STATE OF CONNECTICUT  
CONNECTICUT SITING COUNCIL

DOCKET NO. 506

NEW CINGULAR WIRELESS PCS, LLC d/b/a AT&T  
SUPPLEMENTAL SUBMISSION AND REDIRECT TESTIMONY

AT&T (the "Applicant") respectfully submits the following exhibits and information in response to the Connecticut Siting Council's request for additional information dated December 1, 2021:

**Subject Property Farmland Soils**  
 Proposed Wireless  
 Telecommunications Facility  
 Middletown\_Mile Lane  
 499 Mile Lane  
 Middletown, Connecticut

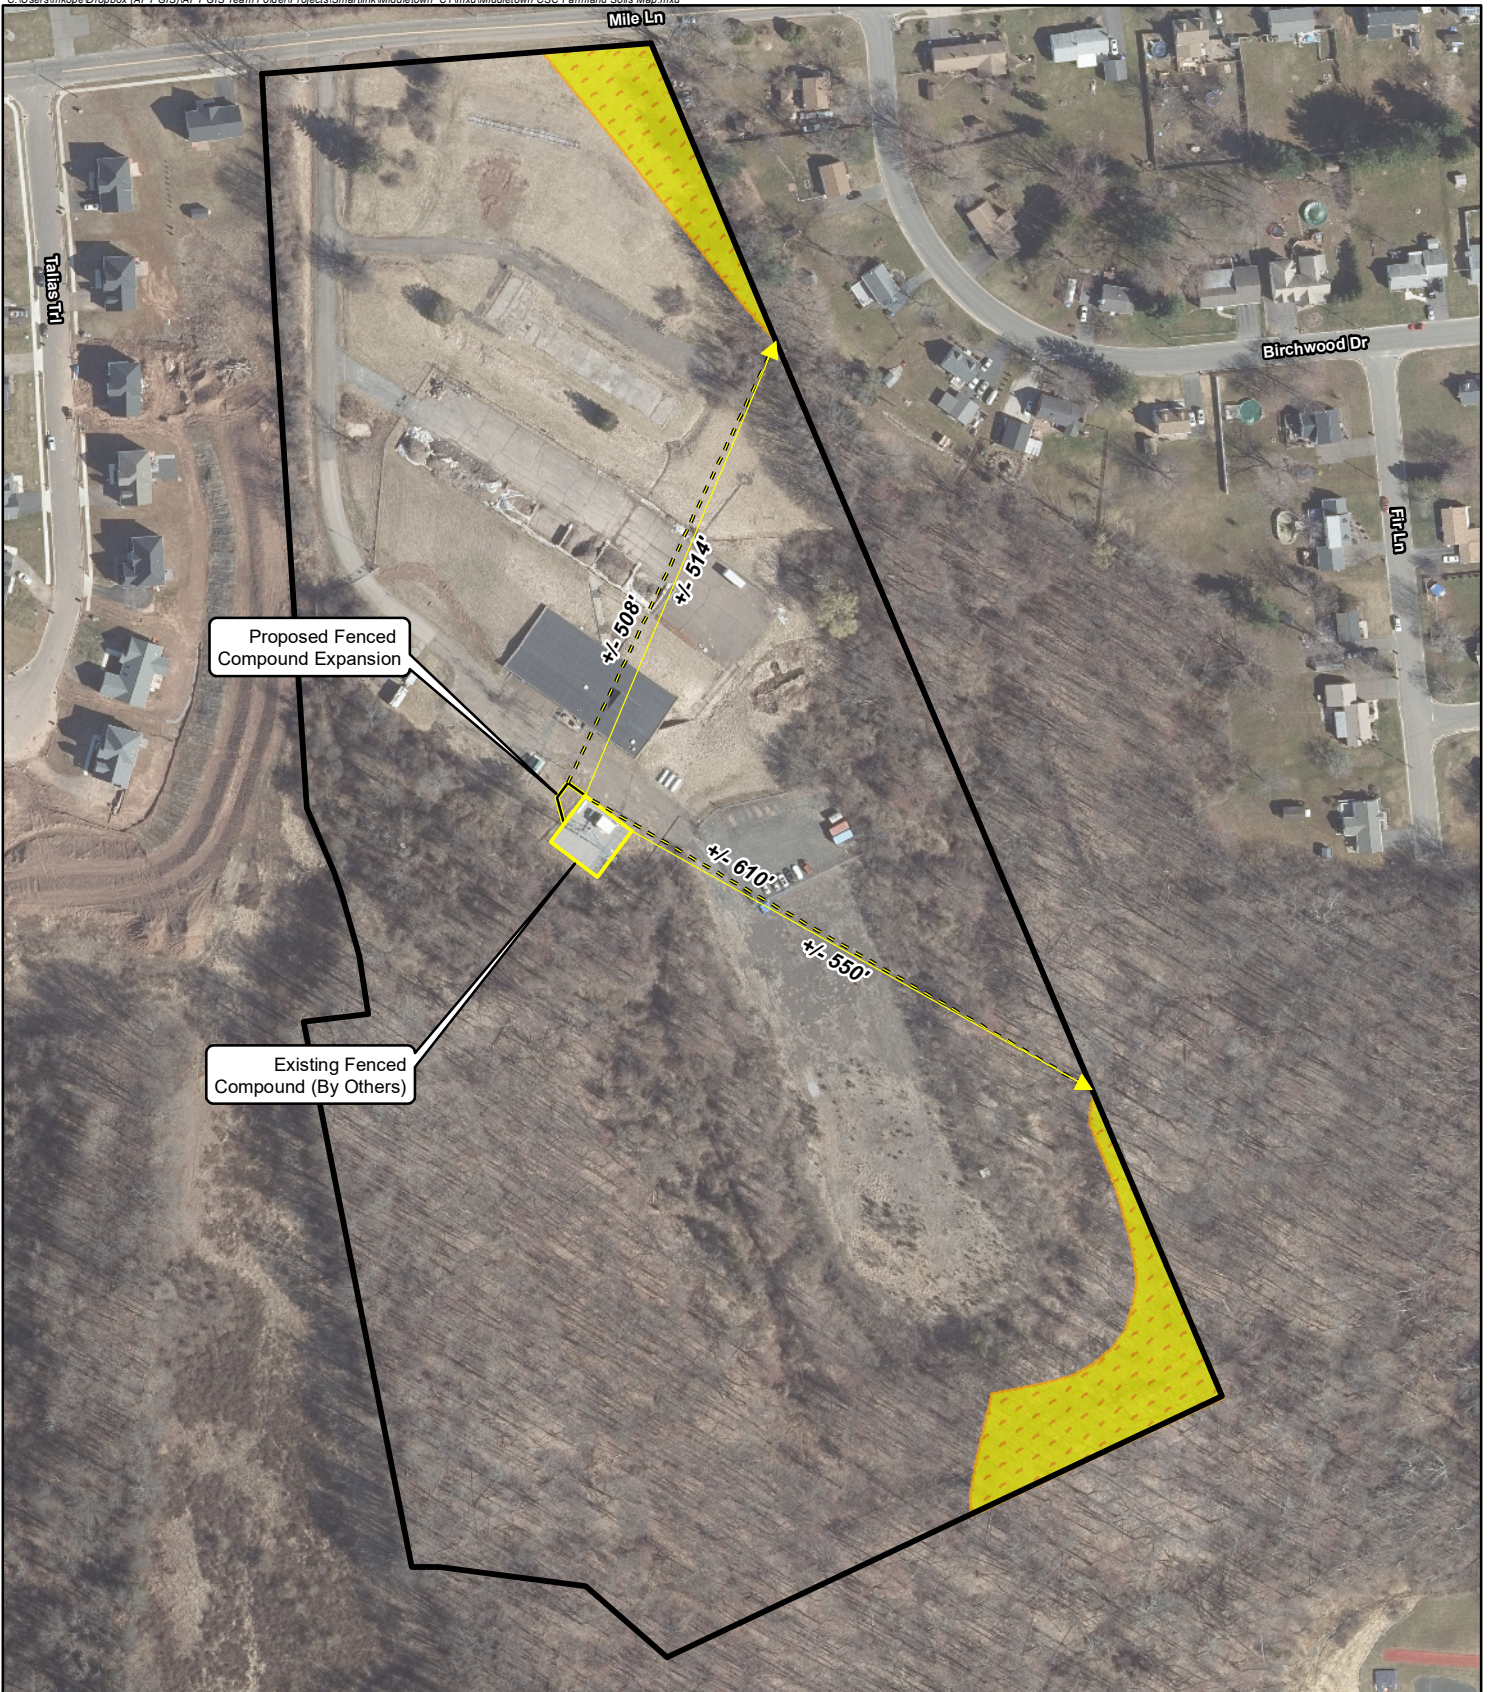
- b) Provide a map depicting the prime farmland soils on the subject property and the proposed compound expansion area.

*Brian Gaudet - Included in Attachment 7 is a map depicting the location of prime farmland soils on the subject property. The nearest Prime Farmland Soils on site are located at the corners of the property over 508' to the northeast of the proposed compound expansion area. The proposed Facility would not impact Prime Farmland Soils.*

**WETLAND SETBACKS** 1  
 22x34 SCALE: 1/8"=1'-0"  
 11x17 SCALE: 1/16"=1'-0"  
 0 4'-0" 8'-0" 16'-0" 24'-0"

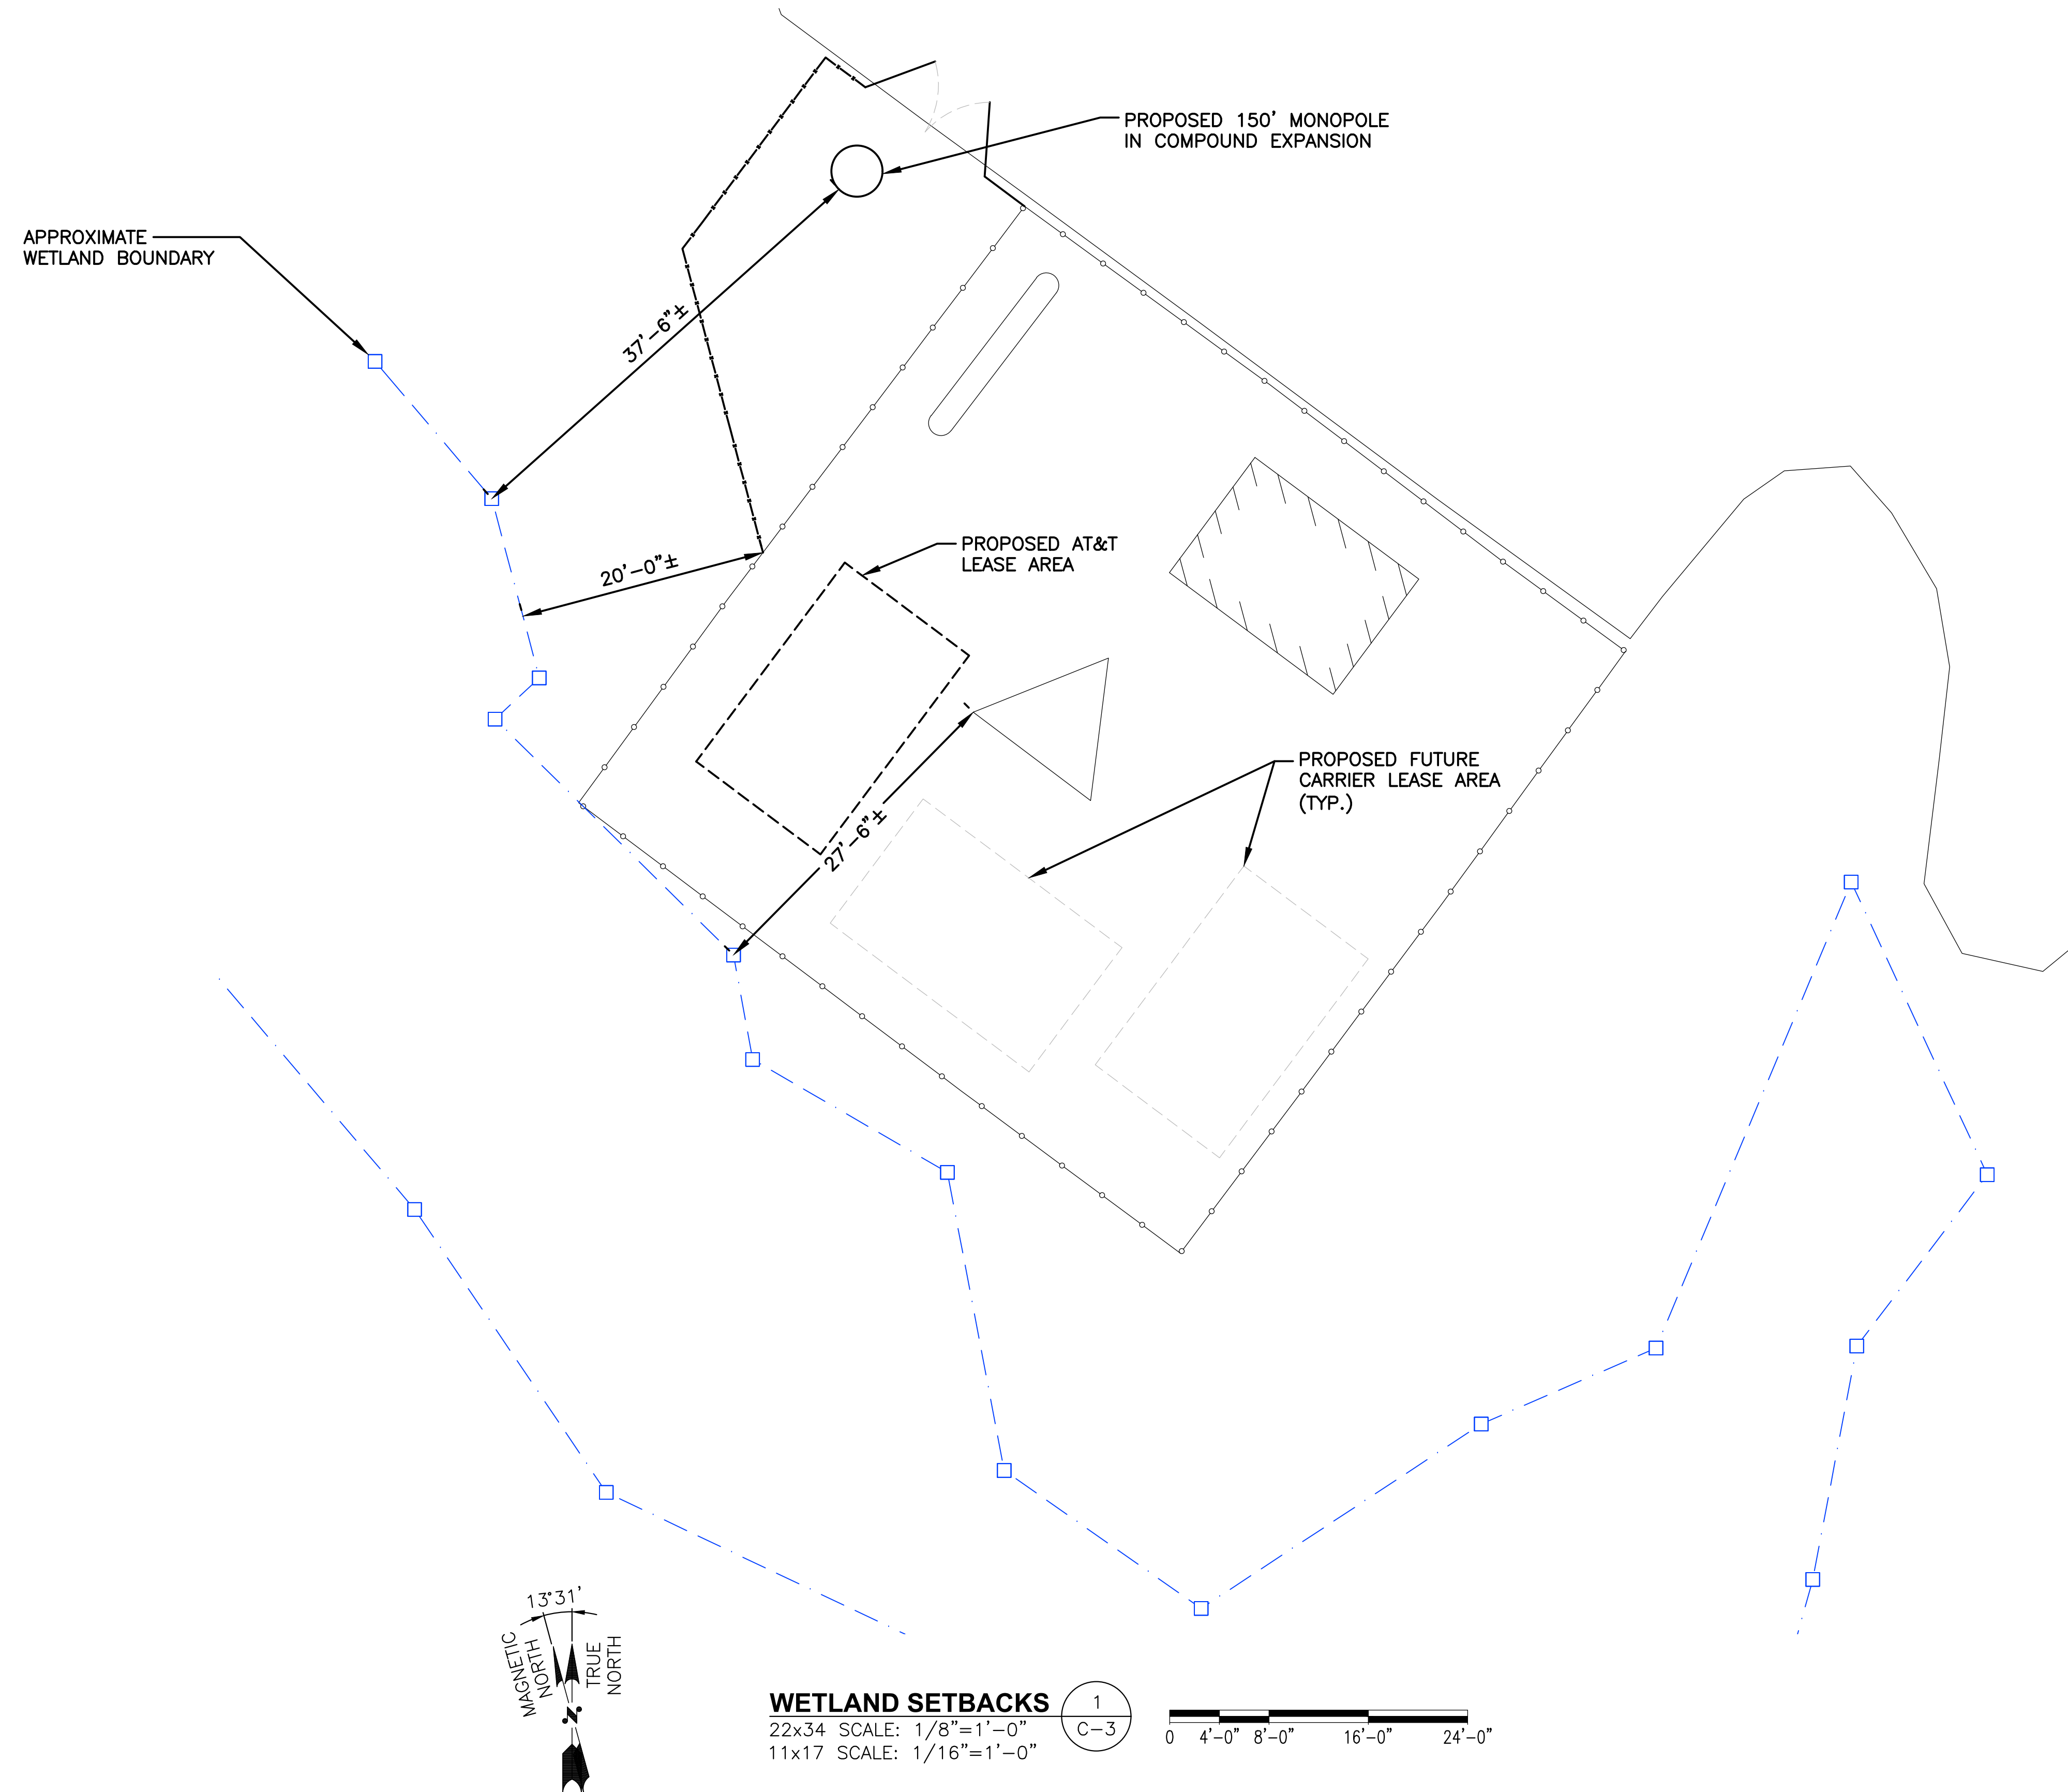
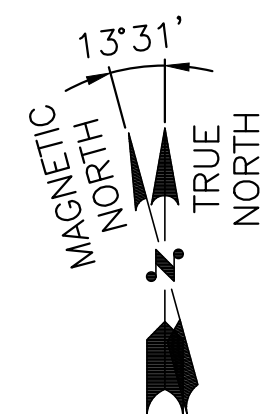
- c) Provide a map of wetlands on the subject property and the proposed compound expansion area.

*Brian Gaudet – Included in Attachment 8 is a map which depicts the location of wetlands on the subject property and in relation to the existing tower site and proposed compound expansion area.*

Figure 1 – Predicted Sound Levels

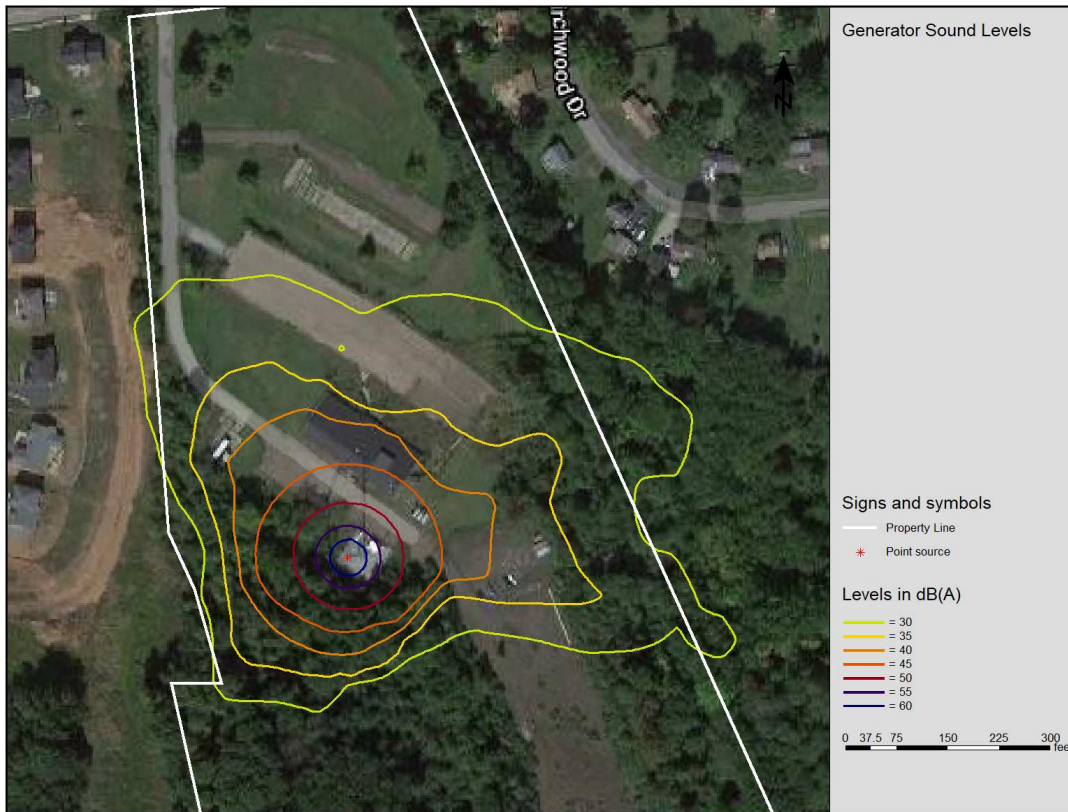
- e) Provide an updated noise study taking into account the proposed compound expansion area location and generator model and fuel source.

*Scott Pike - Included in Attachment 10 is an updated noise study prepared by Reuter Associates LLC, dated December 10, 2021, with updated calculations reflecting the site modifications proposed by AT&T and noting noise at the property lines from the generator would not exceed 35 dBA.*

Figure 1, attached, presents a plot of predicted sound levels. The generator is not expected to exceed 35 dBA at any property boundary.

# NDDDB Map

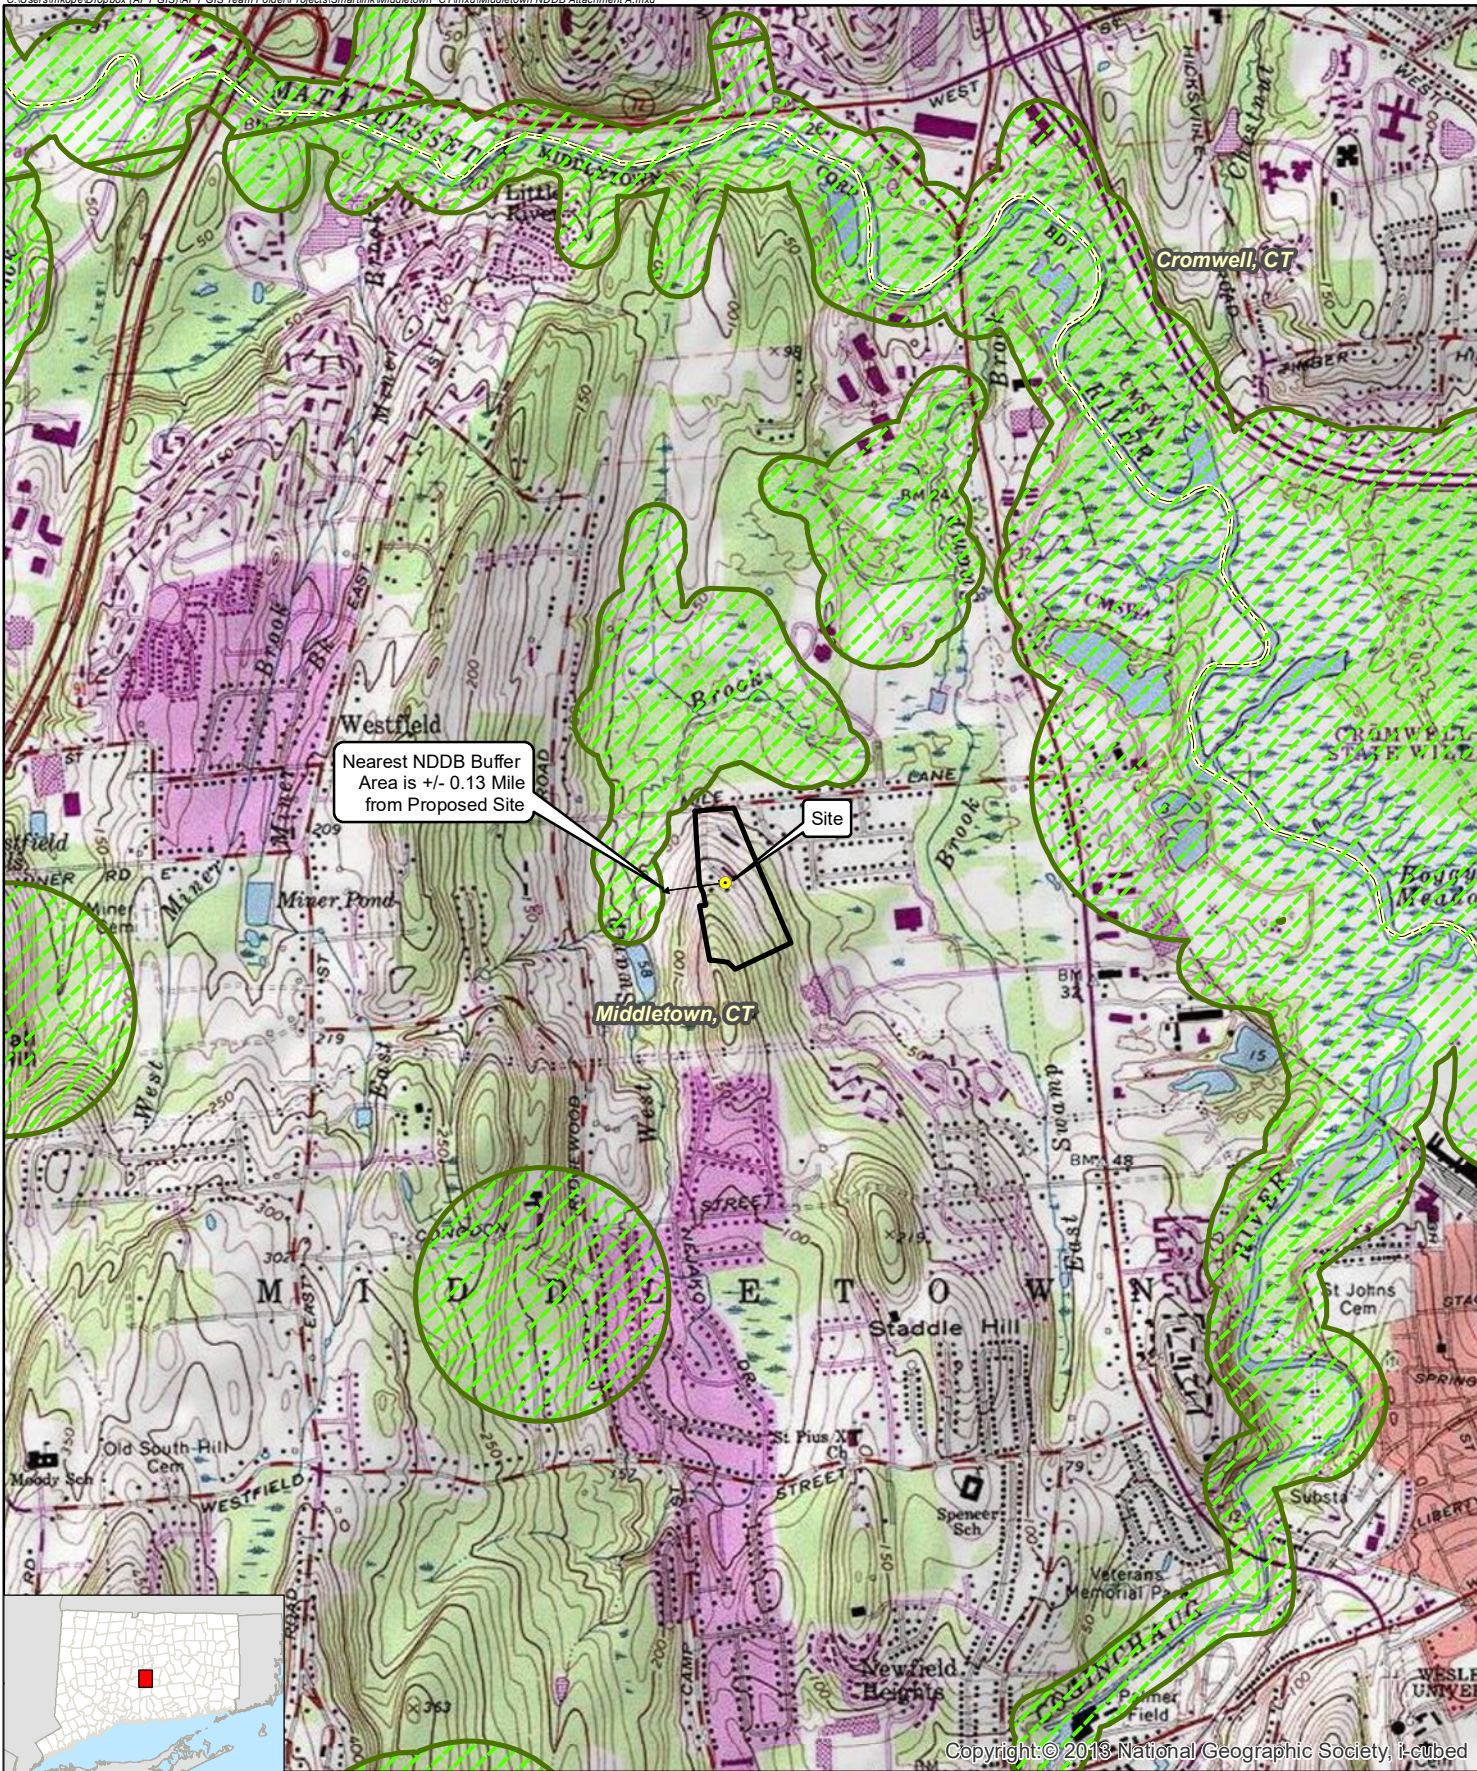
- g) Provide a review of the Natural Diversity Database regarding possible impacts to state-listed species and any associated mitigation measures.

*Brian Gaudet – APT performed an evaluation to assess the presence of any federally- and state-listed, threatened, or endangered species; species of special concern; or, critical*

*habitats. No known areas of state-listed species are currently depicted on the most recent NDDB maps within the Subject Property. The proposed Facility is not anticipated to adversely impact any listed species or critical habitat. Included in Attachment 11 is a USFWS/NDDB Compliance Memorandum documenting this information. AT&T would consider following USFWS voluntary conservation measures, where appropriate and the project schedule allows, to reduce any unlikely potential for impact to northern long-eared bat.*
